UNITED STATES PATENT AND TRADEMARK OFFICE

APPLICATION NO.	FILING DATE	FIRST NAMED INVENTOR	ATTORNEY DOCKET NO.	CONFIRMATION NO.
10/822,572	04/12/2004	Shawn L. Lloyd	ITL.1113US (P18785)	2638
21906	7590	06/07/2005	EXAMINER	
TROP PRUNER & HU, PC 8554 KATY FREEWAY SUITE 100 HOUSTON, TX 77024			HARVEY, JAMES R	
			ART UNIT	PAPER NUMBER
			2833

Office Action Summary

DETAILED ACTION

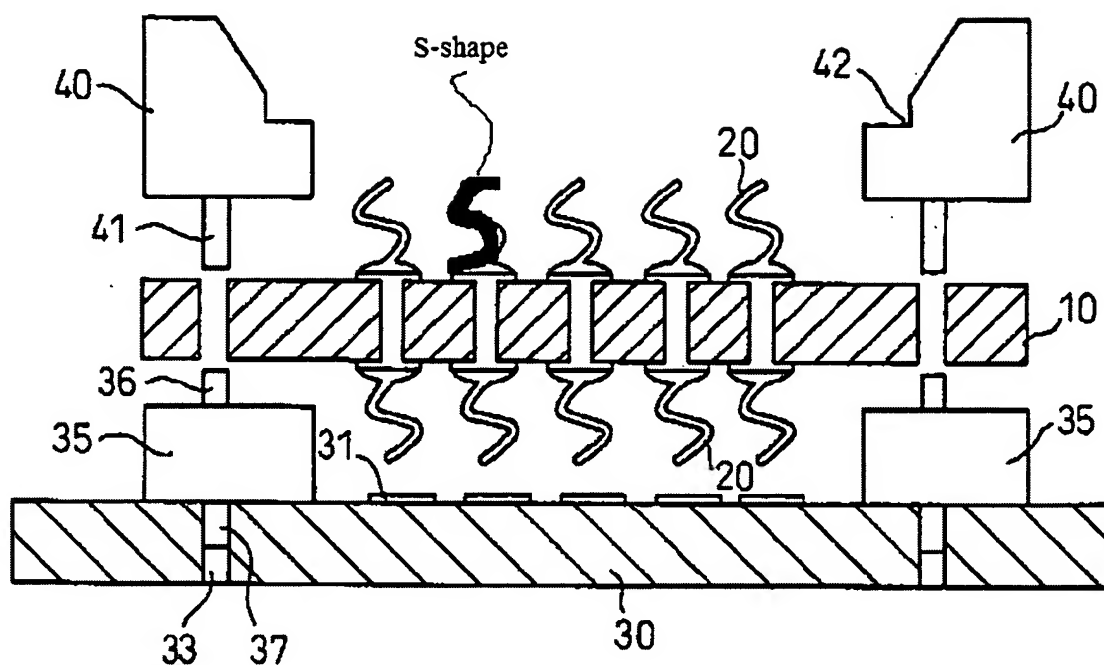
However, Hornchek does not show that the spring contacts are S-shaped.

Higashi shows spring contacts 20 (see examiner's figure) are S-shaped.

It would have been obvious to one of ordinary skill in the art at the time the invention was made to choose the shape spring contact to be an S-shape, since applicant has not presented any explanation that this particular shape is anything more than one of numerous configurations a person of ordinary skill in the art would find obvious for the purpose of providing a mating surface between two parts. A change in shape is generally recognized as being within the level of ordinary skill in the art. In re Dailey, 149 USPQ 47 (CCPA 1976).

Further, it would have been obvious to one of ordinary skill in the art at the time the invention was made to replace the mounting plate 350 with spring contacts 320 of Hornchek with the mounting plate 10 with the S-shaped spring contact 20 Higashi. One skilled in the art would have been motivated to replace the mounting plate and spring contacts because the spring contacts of Higashi are have less components thereby making them easier and less expensive to manufacture.
